**Amendments to the Drawings**

### **Remarks/Arguments**

**FIG. 6**

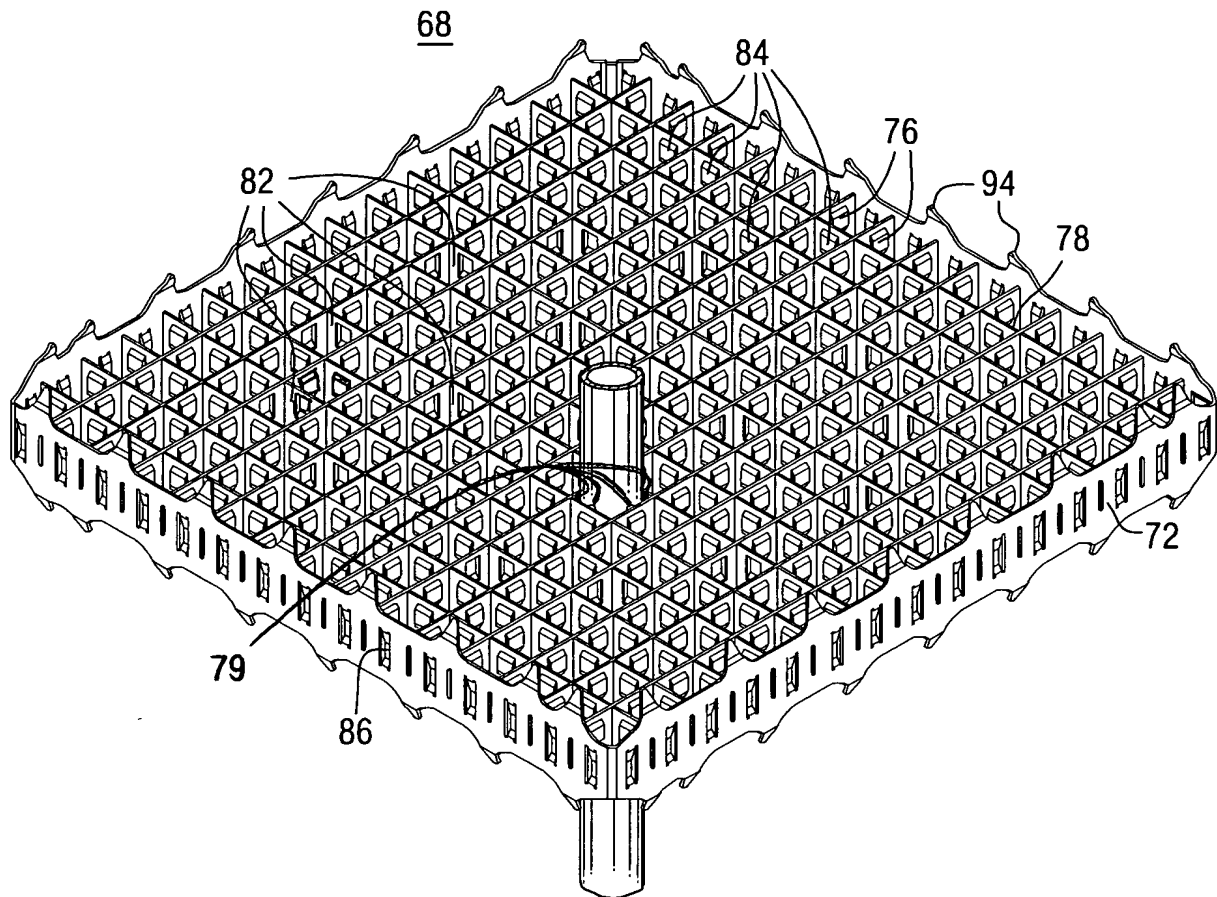
The attached sheet of drawings include changes to Figure 6. This sheet, which includes Figure 6, replaces the original sheet including Figure 6. In Figure 6, the welds that attached the control rod guide tubes to the grid cell are shown more pronounced by reference character 79. Support for this addition may be found on page 11, starting at line 9 et sec. Figure 6 has also been amended to better show that the springs in the grid cells that have springs, i.e., fuel rod support cells, are coplanar and are oriented in the vertical direction. Support for this clarification can be found on page 11, starting on line 5 and on page 11 starting on line 8.

Applicants' attorney respectfully disagrees with the Examiner's position. However, for the sake of advancing prosecution, applicants have further amended Figure 6 to clearly show that the dimples and/or springs are on the vertical and they are all within the same plane. Addressing the relative dimensions, the Examiner's attention is directed to Figure 5, which clearly shows the springs on a diagonal with the contact area shown relative to the width of the cell as being substantially less than that shown for the vertical springs and dimples shown in Figure 6 relative to the cell wall width illustrated in Figure 6. The Federal Circuit in *Hockerson-Halberstadt Inc. v. Avia Group International, Inc.* (222 F.3d 951, 956, and 55 USPQ 2d 1487, 1491 Fed. Cir. 2000) stated: "It is well established that patent drawings do not define the precise proportions of the elements and may not be relied on to show particular sizes if the specification is completely silent on the issue." Thus, the court is acknowledging that the patent drawings do not have to show the precise proportions. Here, however, the specification does add to the drawings by clearly stating on page 11, starting at line 6, that the dimples and/or springs are co-planar, and on line 8, that the springs are on the vertical rather than on the diagonal. Starting at line 29, the specification specifically states: "The inner straps 76 and 78 on the auxiliary grids provide for a larger contact area between the dimple/springs and the fuel elements than are provided by the corresponding contact areas on the main support grids 46. The Court of Customs and Patent Appeals stated in *In re: Chitayat*, 408 F.2d 475, 161 USPQ 224 (CCPA 1969) that: Arguments based on mere measurement of patent drawings are of little value in absence of description in specification of relative dimensions. Here, we have both a clear statement in the specification and the

With regard to Claim 13, which calls for the auxiliary grids being maintained in the their axial position by being mechanically or metallurgically affixed to some of the guide tubes, reference character 79 has been added to Figure 6 to clearly show weld connections between the guide thimble and the grid straps. It is well known in the art that a weld creates a metallurgical connection between the welded members, and the references cited by the Examiner evidence that it is also well known to create a mechanical connection at that joint as a means of affixing the guide thimbles or sleeves that guide thimbles are attached to, to the cell walls. Figure 6 clearly demonstrates this principle and should now be acceptable. Accordingly, the removal of the objection to Claim 13 is also requested.

The Examiner asserted that the amendment filed 9/24/04 is objected to under 35 USC § 132 because it introduces new matter into the disclosure. The Examiner asserted that Figure 6 shows a 15 X 15 array, not a 17 X 17 array. Applicants fully agree. The earlier amendment was a typographical error. Figure 6 shows the 15 X 15 array and Figure 4 shows the 17 X 17 array. This further amendment has been made to the specification to correct this error.

Annotated sheet showing exemplary changes in red.
